Proposed Changes to the Technical Specifications
Related to the License Amendment Request for the
Upgrade of the Instrumentation and Control System
for the
Armed Forces Radiobiology Research Institute
TRIGA Reactor

7 January 2022

Figure 2-1 – Ranges of Operation for the NMP-1000

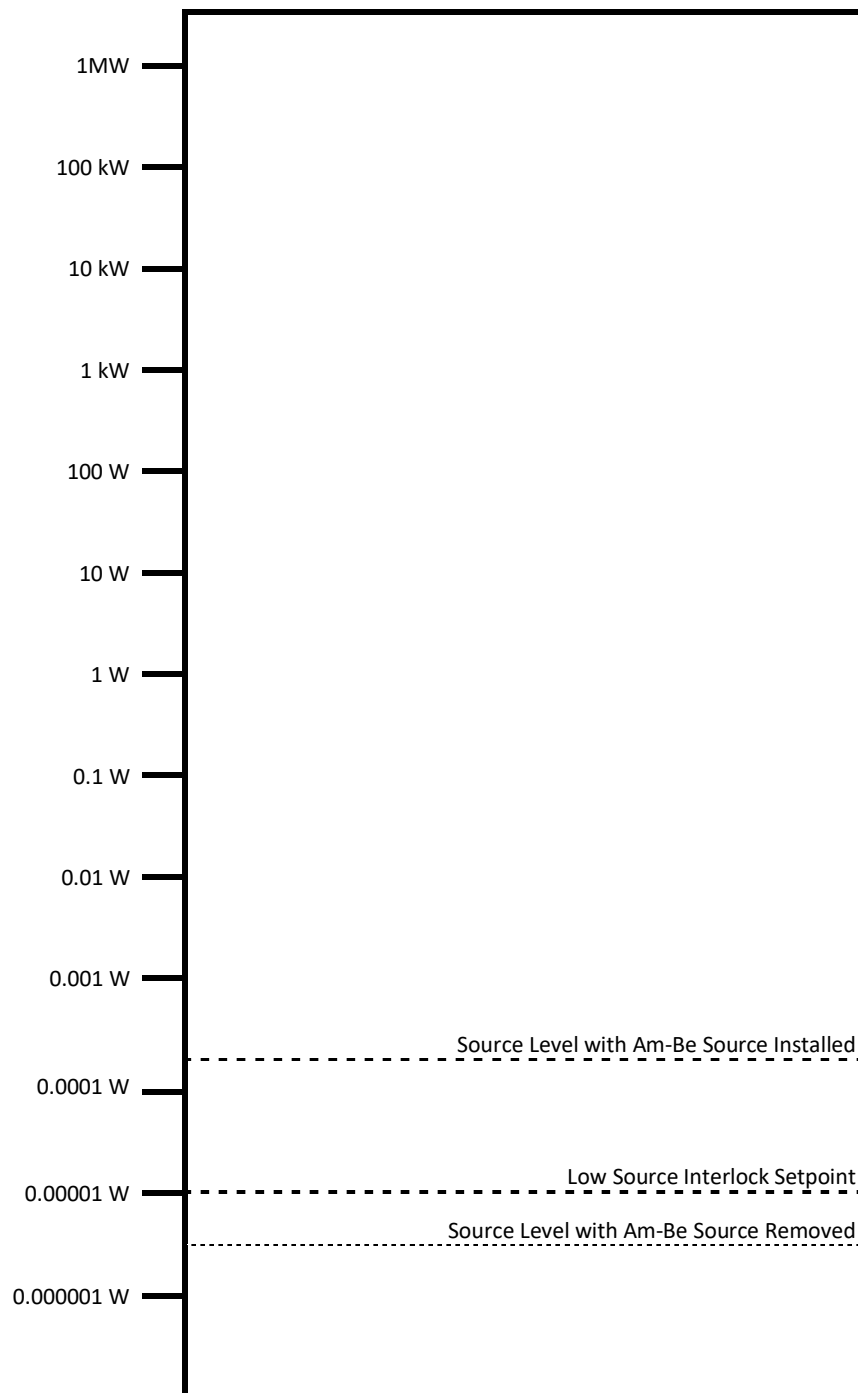
From Figure 2-1, it is shown that a setpoint of 1×10^{-5} watts is well above the level when the source is removed which provides assurance that channel is operating correctly by detecting sufficient source neutron prior to startup. Therefore, it is concluded that the proposed change to Table 3 of TS 3.2.2 for the source range interlock will continue to perform the design function required by this channel.

Figure 4-2 – Core Dolly Limit Switch Diagram

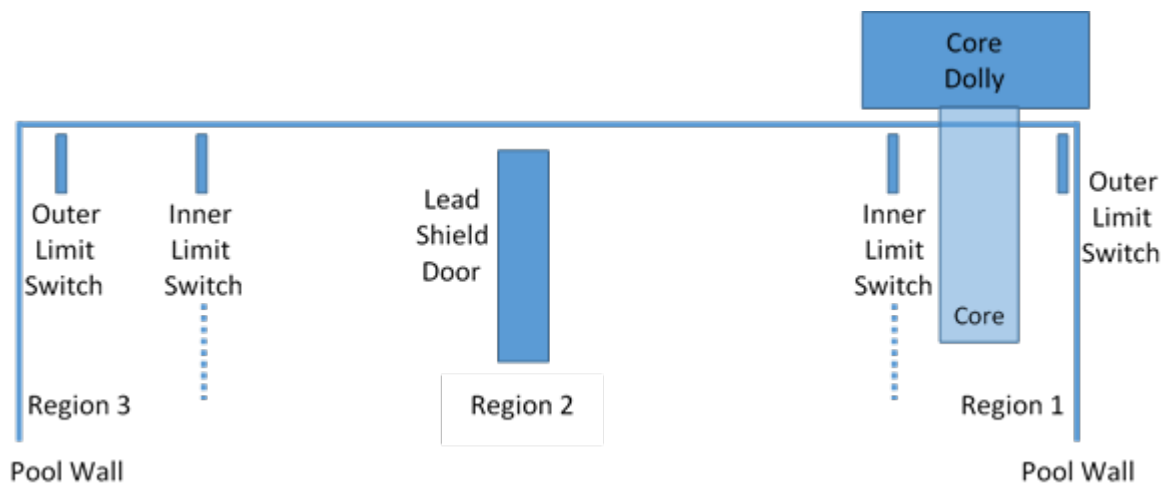
For each region there are two limit switches that will stop core dolly movement - the inner and outer limit switches. Refer to Figure 4-2 for a diagram of the switches. The outer limit switch stops the core dolly when it reaches the far end of the travel to prevent contacting the pool liner. The outer switches cannot be overridden. To prevent contact with the lead shield doors, the inner limit switch stops the core dolly from further movement if the lead shield doors are not fully opened.

Figure 4-3 – Core Dolly Limit Switch Access Point

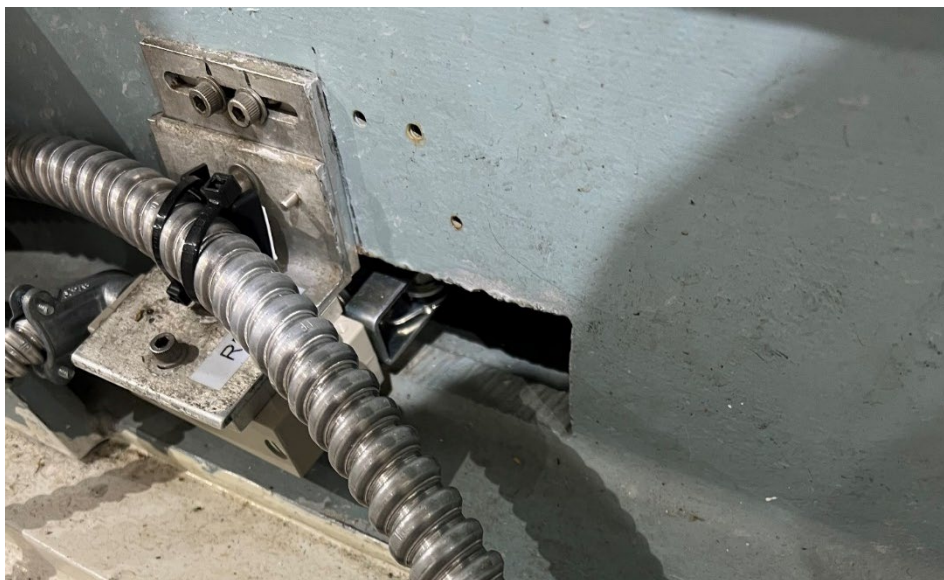
For example, take the scenario of the operator moving the core dolly toward region 3 with the lead door closed. Once the core dolly comes off of the inner limit switch (switch is now open) the core dolly will stop and further movement of the core dolly is prohibited, this includes movement back toward region 1. Originally, the only way to recover from this scenario was to manually actuate the switch. This was accomplished by inserting a finger through a cutout in the core dolly rail and pushing down on the lever arm of the switch. Refer to Figure 4-3 below.

This introduced a potential pinch/crush hazard to personnel who performed this task. This scenario would occur (twice, Steps 3 and 69) during the performance of *M033 Facility Interlock Checklist* procedure. To eliminate the hazard, the previous FIS was modified and an override switch was added to the inside of the cabinet. Refer to Figure 4-6. The new FIS cabinet maintains this functionality.

Figure 4-4 – Core Dolly Override Switch

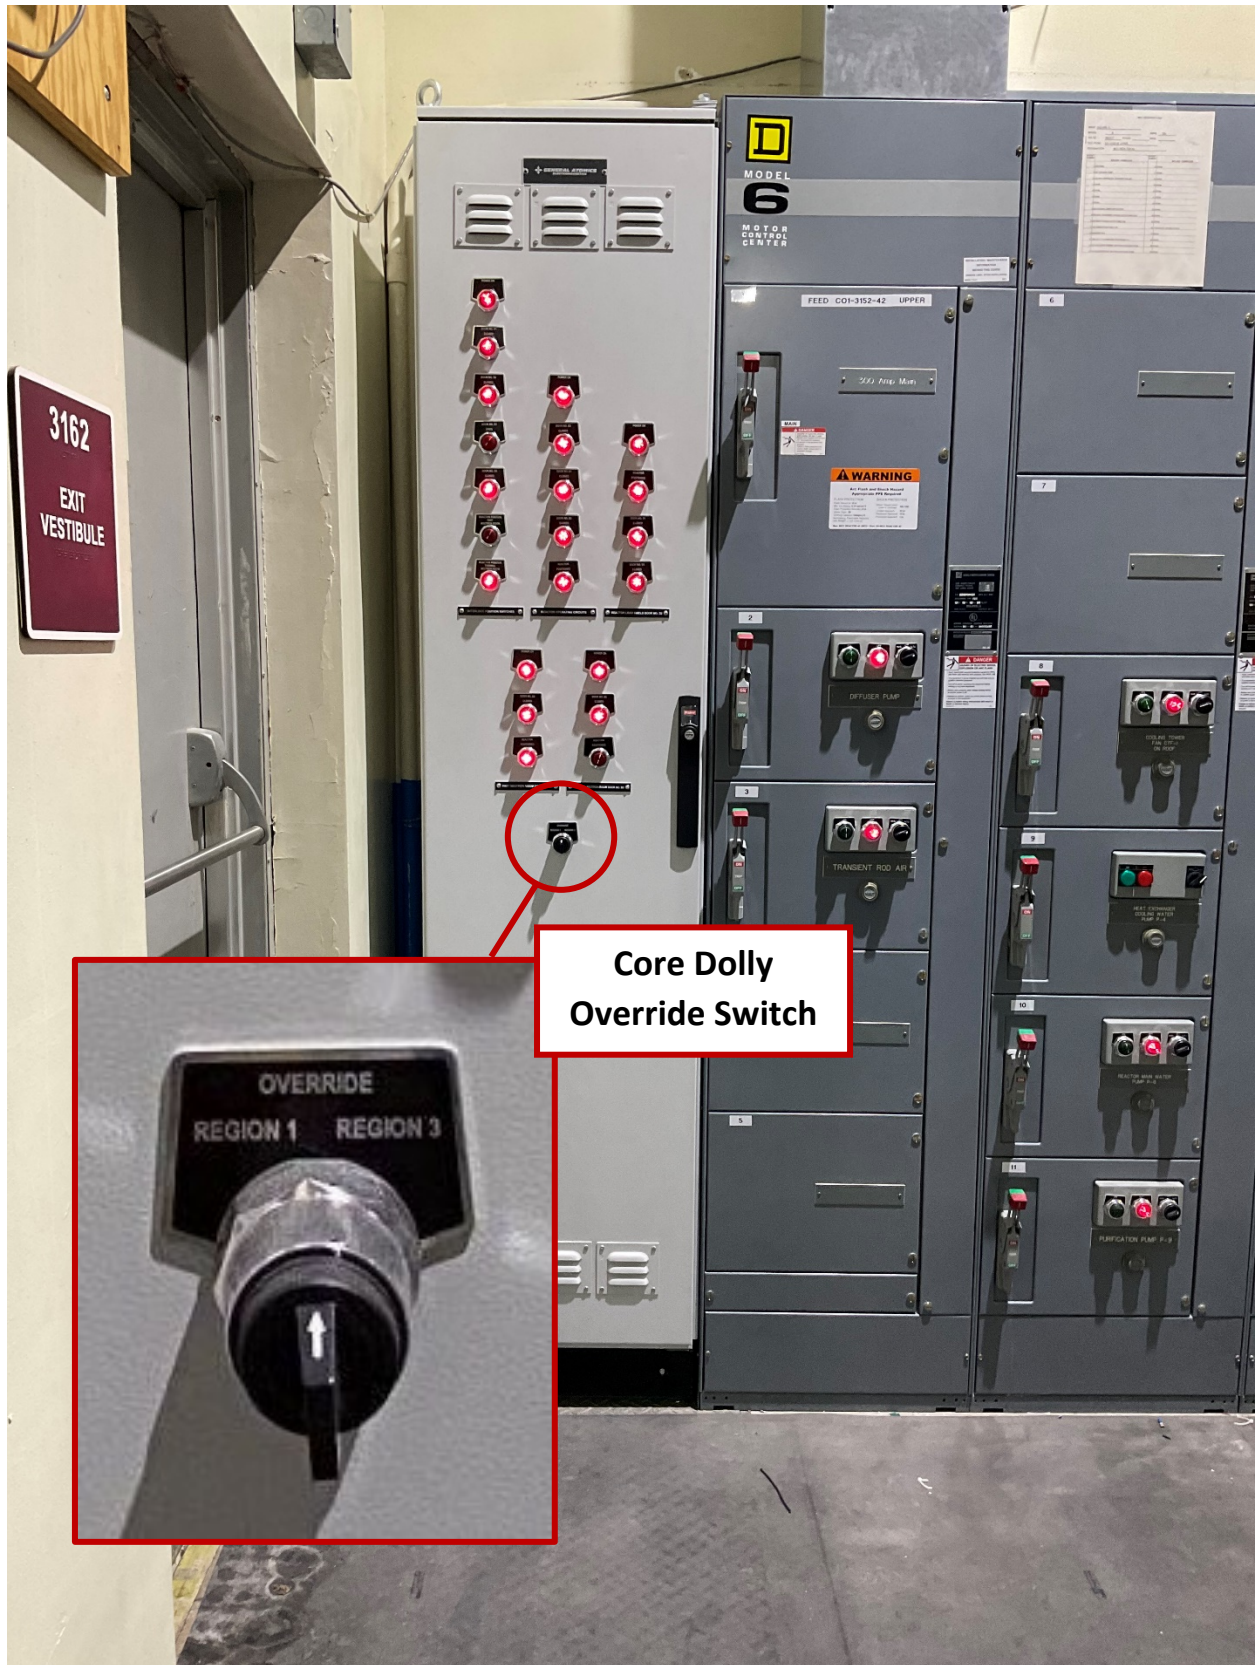
As part of the digital instrumentation and control upgrade, a core dolly override switch was added to the front of the Facility Interlock Cabinet (FIS). The O&M Manual briefly describes the override switch as toggle switch RP2. Refer to Page 3-28 of the O&M Manual and Drawing T3A100E840 Rev B. Figure 4-1 shows a close up of the switch, while Figure 4-4 shows that location of the switch on the FIS cabinet.

The use of the override switch is administratively controlled such that trained reactor personnel are required to be directly supervising the core movement while the switch is engaged. This requirement is inherently enforced since the override switch is momentary and has to be actively held in place to permit movement of the core dolly. In the event of operator error or equipment malfunction the torque generated by core dolly drive mechanism is limited by a slip clutch. The slip clutch is set to prevent damage if the core shroud or any other part of the core dolly comes into contact with an obstruction, such as the core shroud contacting the lead shield doors. As such, a failure resulting in inadvertent contact between the core shroud and an obstruction has minimal consequences. Therefore, movement of the core dolly in region 2 while the lead shield doors are closed during maintenance activities does not impose any undue risk to the health and safety of the reactor, reactor personnel or to the public.

- a. With the lead shield doors open, neither exposure room plug door can be electrically opened.
- b. The core dolly cannot be moved ~~into~~ in region 2 with the lead shield doors closed except during the use of the core dolly interlock override switch.
- c. The lead shield doors cannot be opened to allow movement into the exposure room projection unless a warning horn has sounded in that exposure room, or unless two licensed reactor operators have visually inspected the room to ensure that no personnel remain in the room prior to securing the plug door.
